UNITED STATES ENVIRONMENTAL PROTECTION AGENCY

RE: Review of the March 31, 2016 "Soil Site Characterization Summary Report" Former Manufacturing Plant Area – Sherwin-Williams/Hilliards Creek Superfund Site, Gibbsboro, New Jersey.

Comments on the Soil SCSR for FMP soils

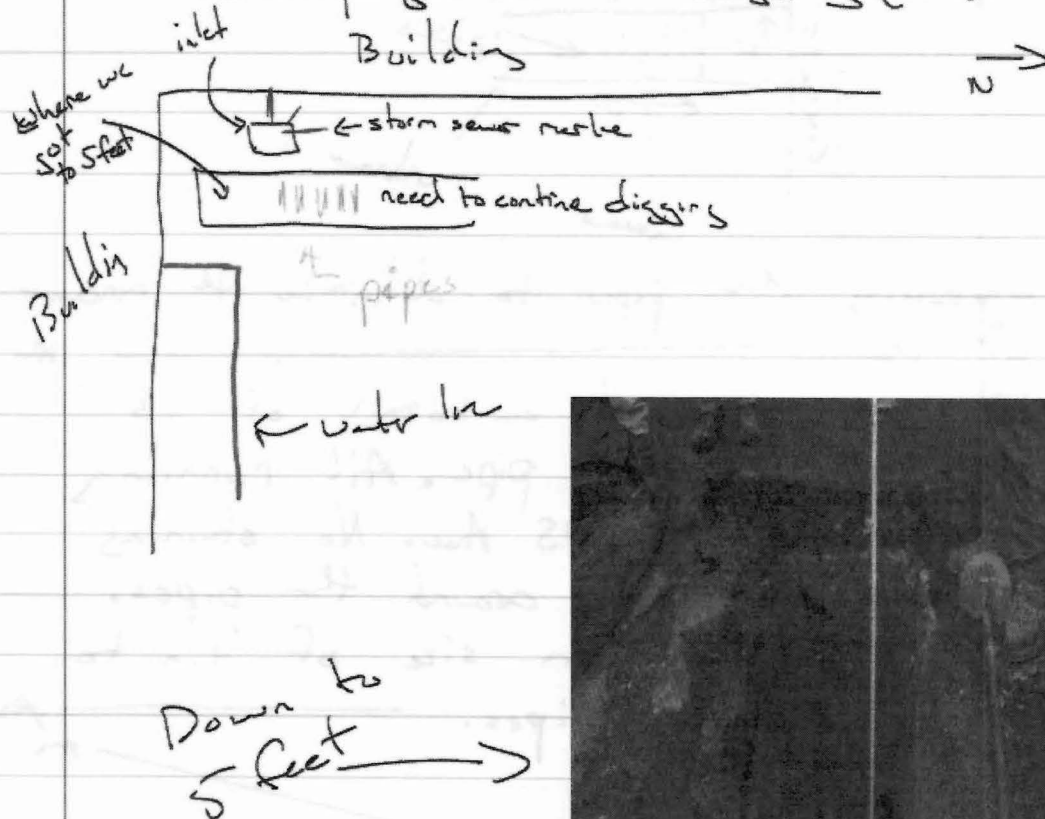
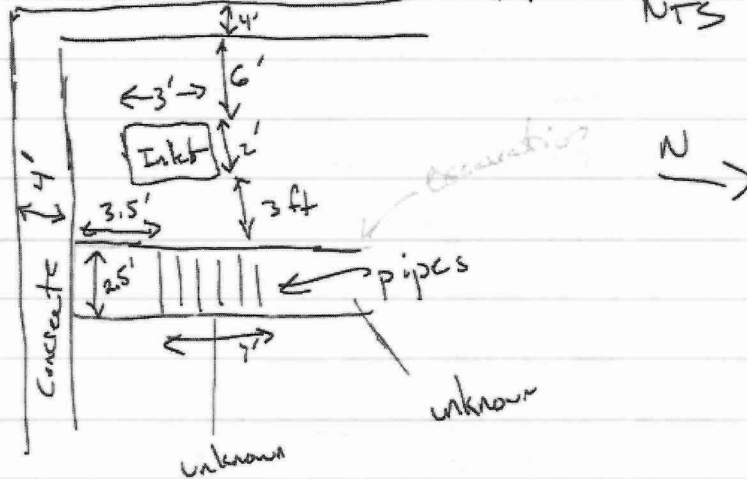
6. Page ES-3 – Geophysical Investigation – EPA is requesting that the statement that no evidence of any on-going source(s) of contamination or any conduit(s) through which contaminants is being transported to be removed. Several of the trenching activities (12/17/2012) and (5/10/2010) revealed piping, of which the beginning and terminus of them were not delineated. In addition, at each of these locations, PID readings, stained soils, odors and in the case of the excavation area on 5/10/2010, elevated XRF readings (lead was above 8,000 ppm in source material), were observed. During the 12/17/2012

trenching activities, thirteen (13) pipes were observed (Attachment 2 – Field Notes from 12/17/2012).

55. Section 4.2, page 4-6 – Do not agree with Sherwin-Williams' conclusion that there are no conduits through which contamination is being transported. The excavation activities that occurred on 12/2012 were unable to trace the full extent of the 13 pipes present.
